UNIVERSAL ACCESS FUND RTP
SITE VALIDATION & ACCEPTANCE
REPORT - PARLUKEN

15 February 2021

DRIVE TEST (DT)

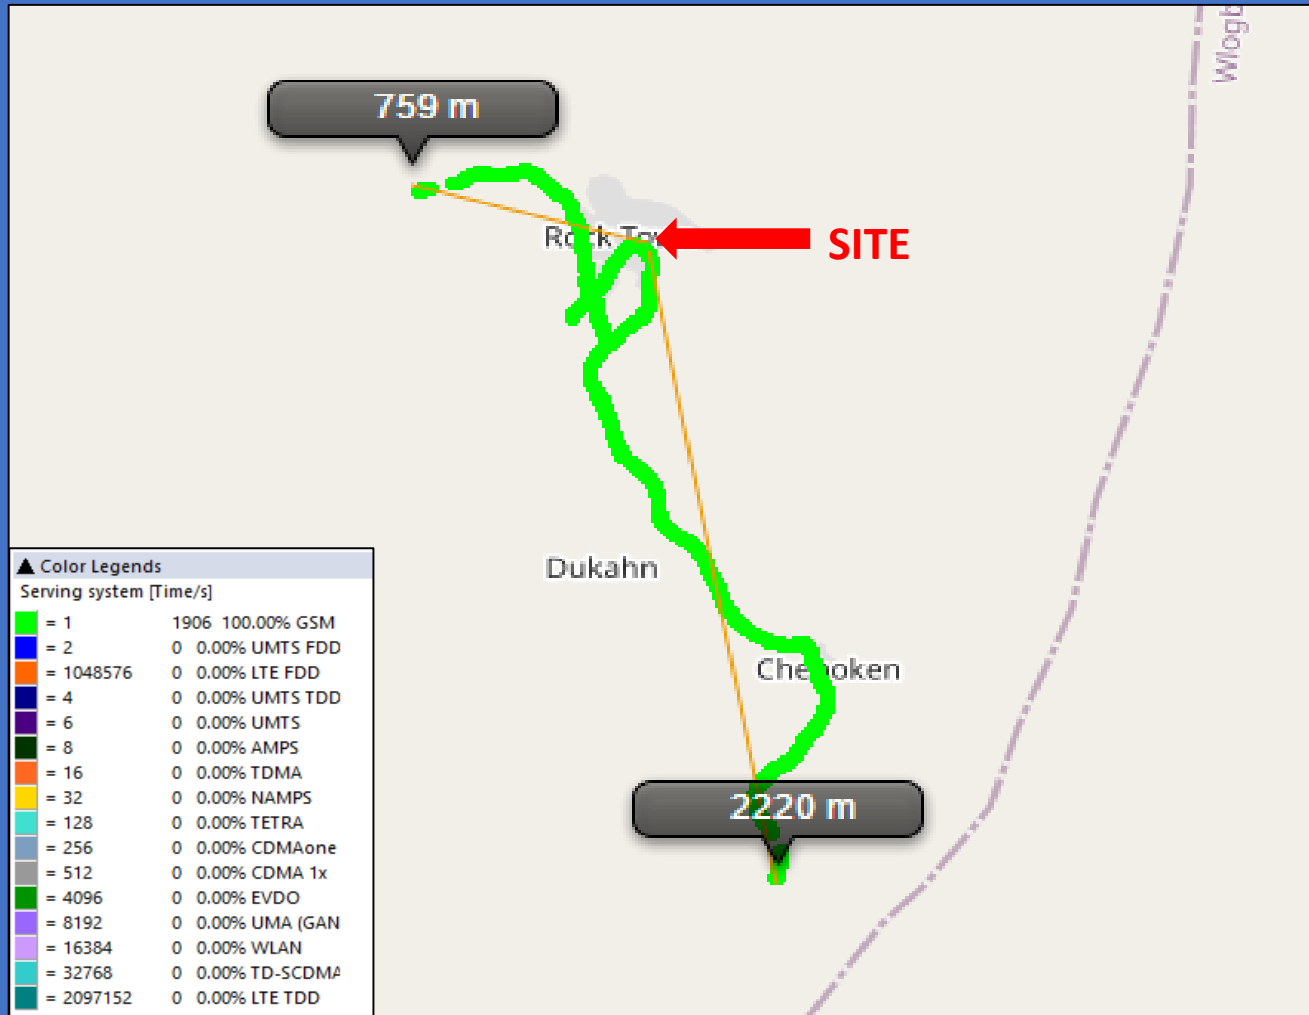
The site coverage radius is about maximum 2.2 km with 100% in 2G network.

- Enable or check 2G EDGE parameter settings for internet connectivity.
- Check parameter settings to reduce call setup time to <15 sec.
- Optimized site RF antenna and/or check parameter settings to improve cell coverage radius to 5 km.

DRIVE TEST (DT)

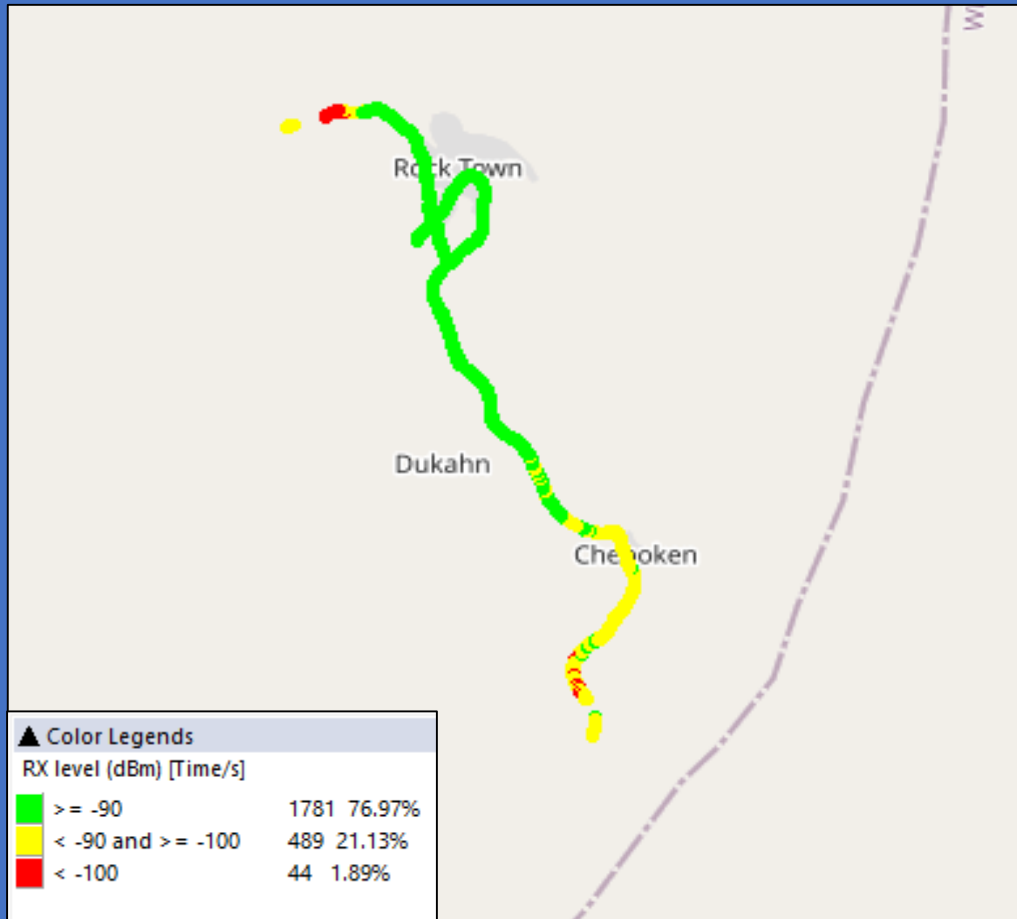
GSM coverage of the site is normal.

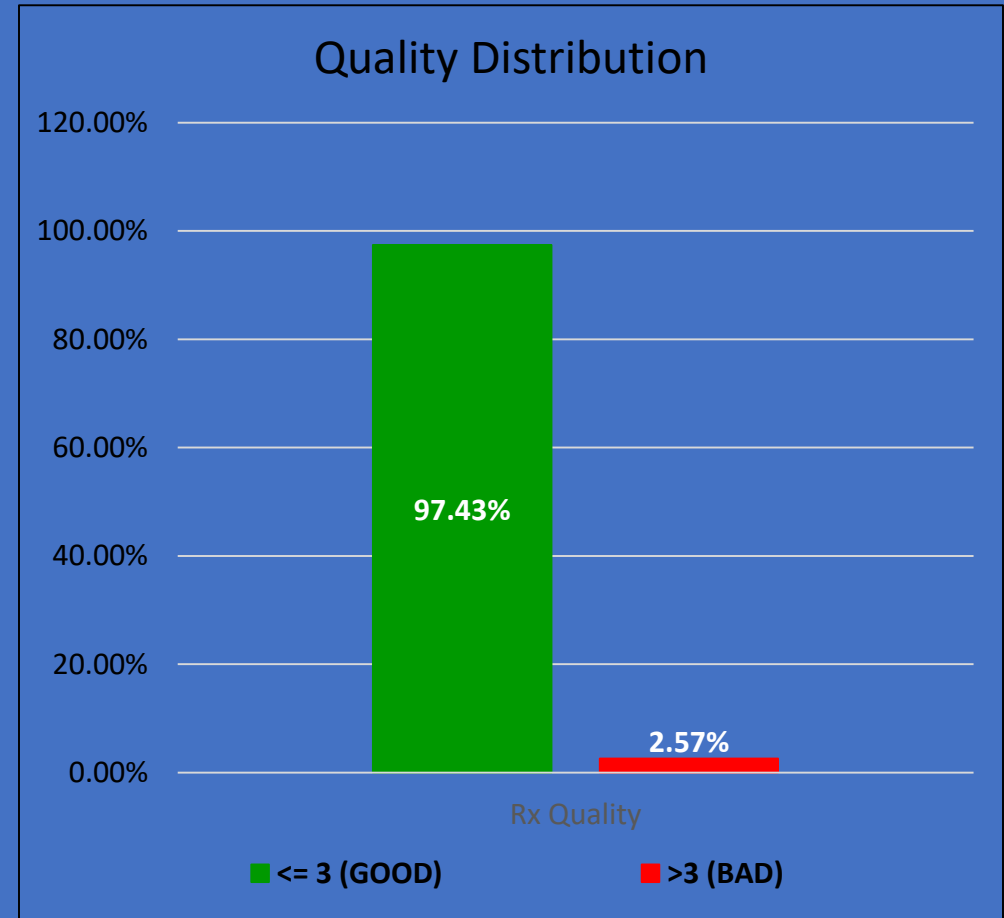
Signal Quality distribution. Bad quality originates from degradation in coverage.

DRIVE TEST (DT)

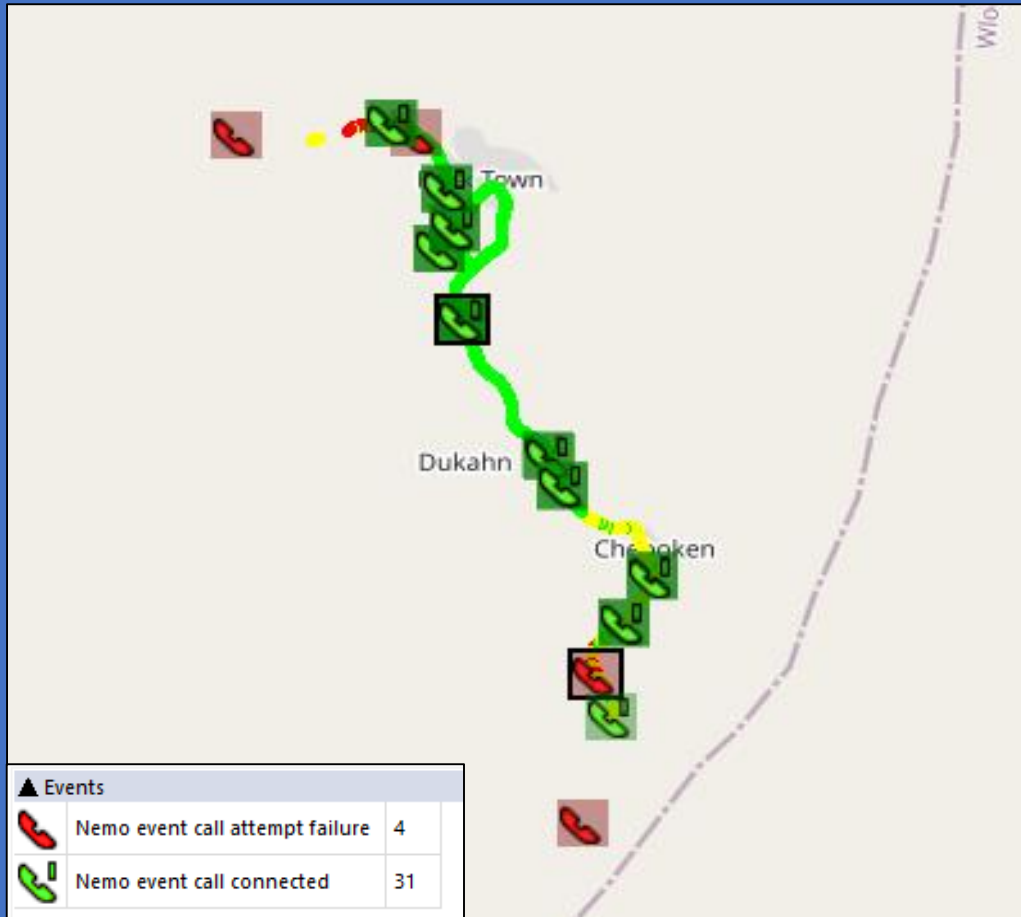
4 of the 35 calls failed; caused by weak signal level.

2 calls dropped due to poor coverage.

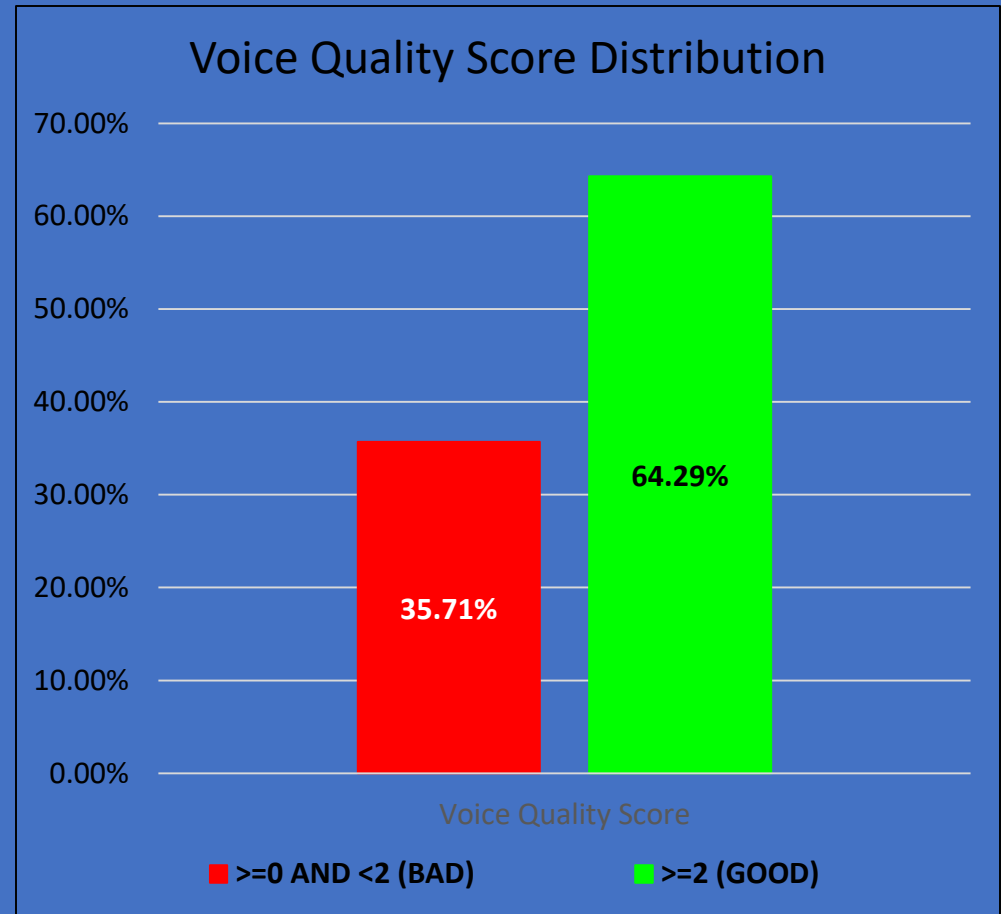
About 64% of the voice calls had good voice quality

DRIVE TEST (DT)

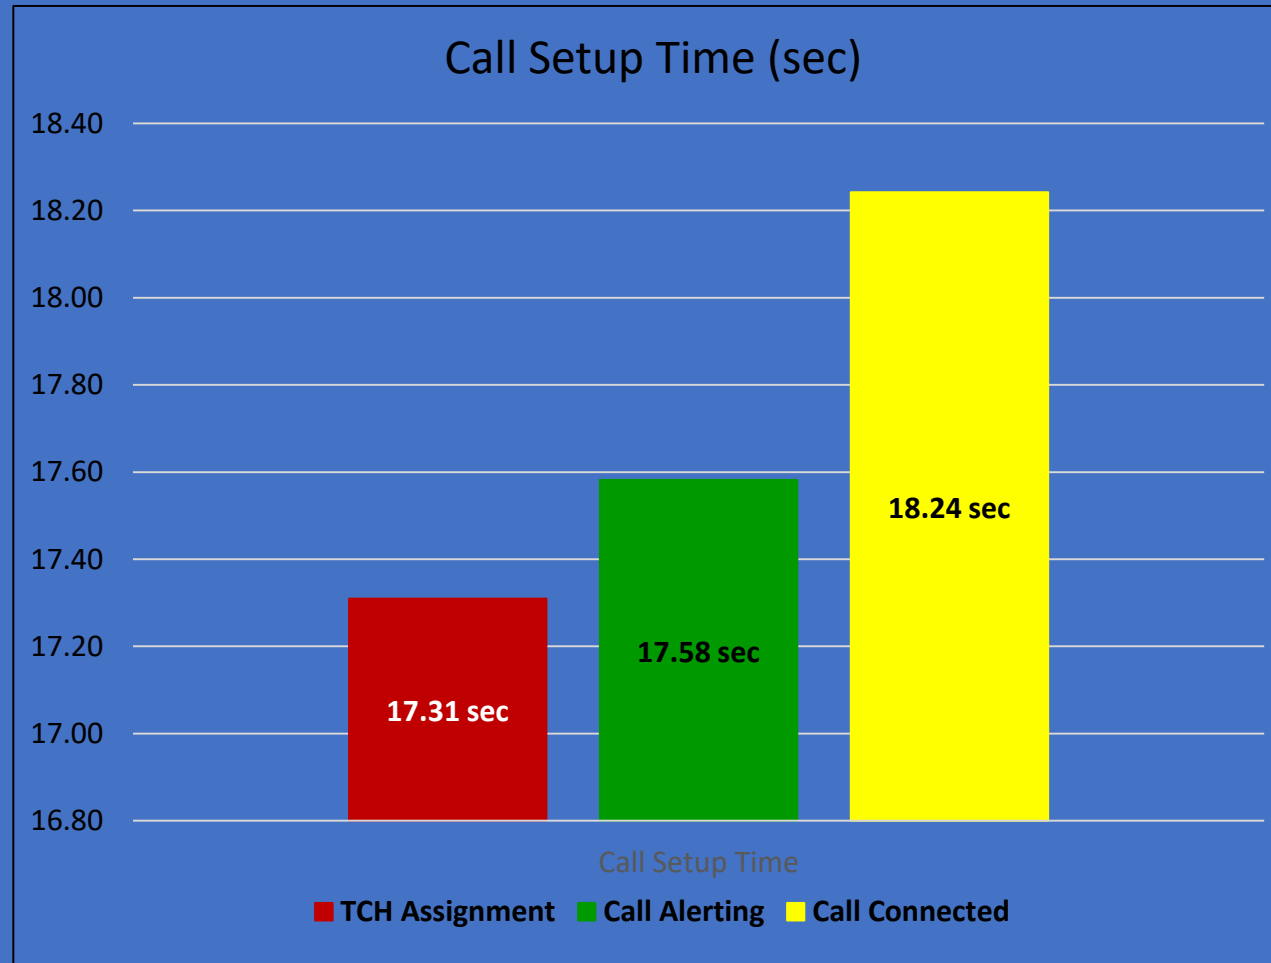
Average Call Setup Time is more than 2 times the normal (8 sec)

DRIVE TEST (DT)

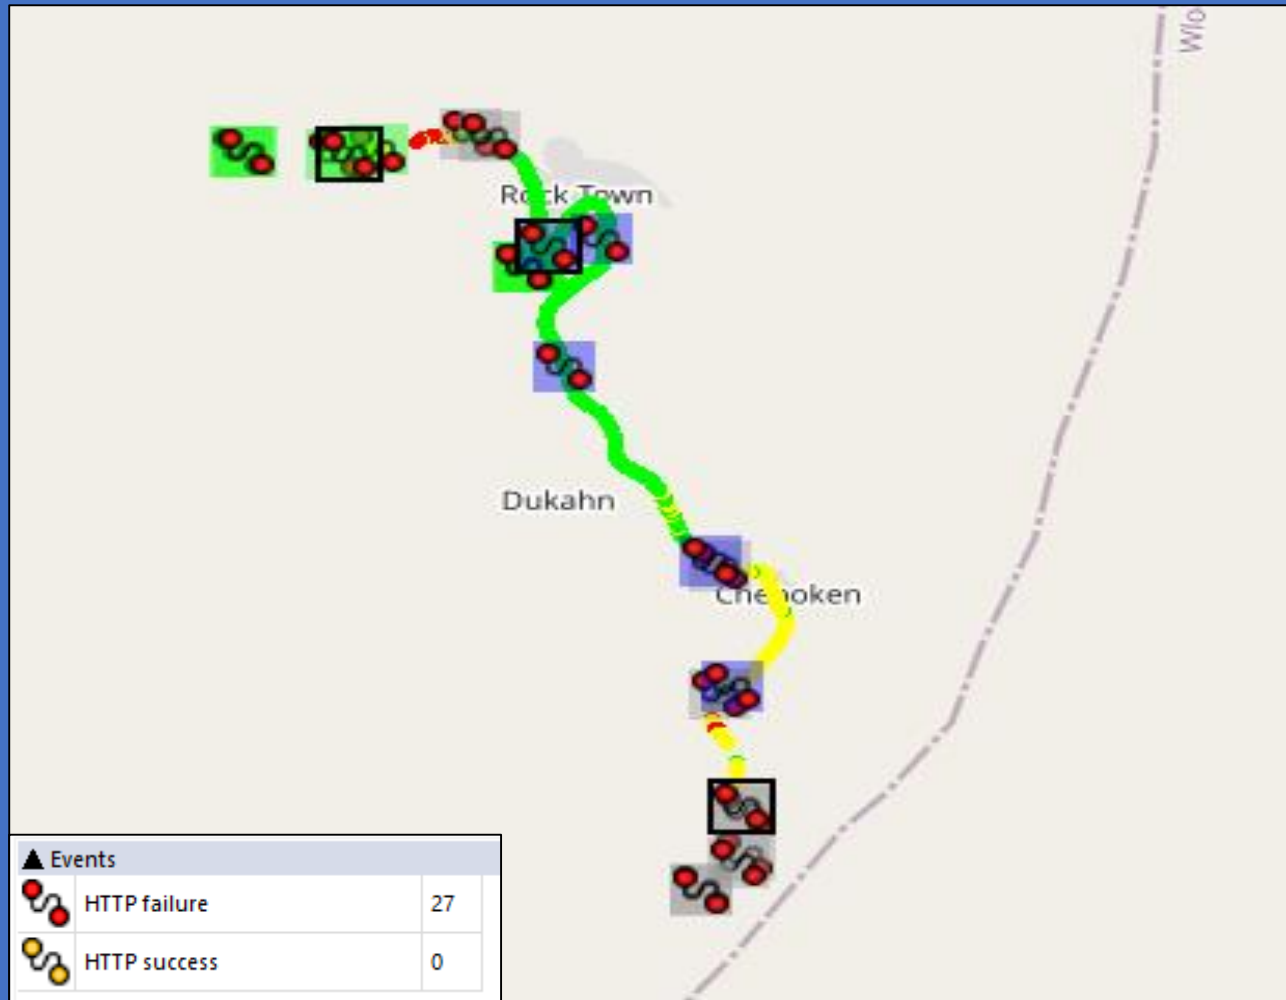
All 27 browsing attempts failed; Due to no internet connectivity
